# NOTICE OF DECISION

**CLASS 1 MINOR HISTORIC DESIGN REVIEW CASE NO.: HIS23-14**

**SUMMARY:** A proposal to replace siding on the exterior of the Mary Fawk House (c.1919).

**LOCATION:** 1297 High St SE

Figure 2

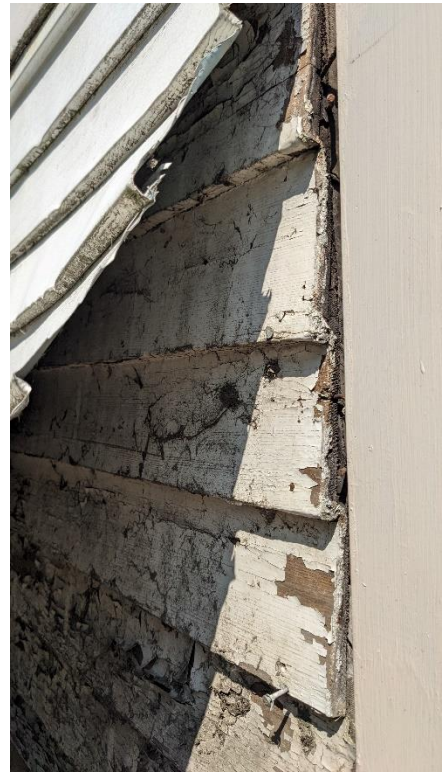
Criteria	Statement of Compliance
<p>Replacement of siding, exterior trim, and minor architectural features of historic contributing buildings shall be allowed only where the owner has attempted to repair the original siding, exterior trim or minor architectural feature, but repair was determined to be unfeasible due to poor condition of the original materials.</p>	<p>The wood siding underneath the aluminum was extensively modified as part of the aluminum siding installation process. Areas that have been exposed show that it was cut around the door trim. Windowsills in all but the street-facing windows were notched at the ends.</p> <p>Figure 2 shows a close up of the aluminum siding, and an example of its disrepair.</p> <p>Figure 3 shows a small section of the wood siding underneath the aluminum and its state of disrepair. Contractor has advised that moisture trapped behind the aluminum may have damaged the wood in areas still uncovered. The peeling paint is likely lead paint.</p>
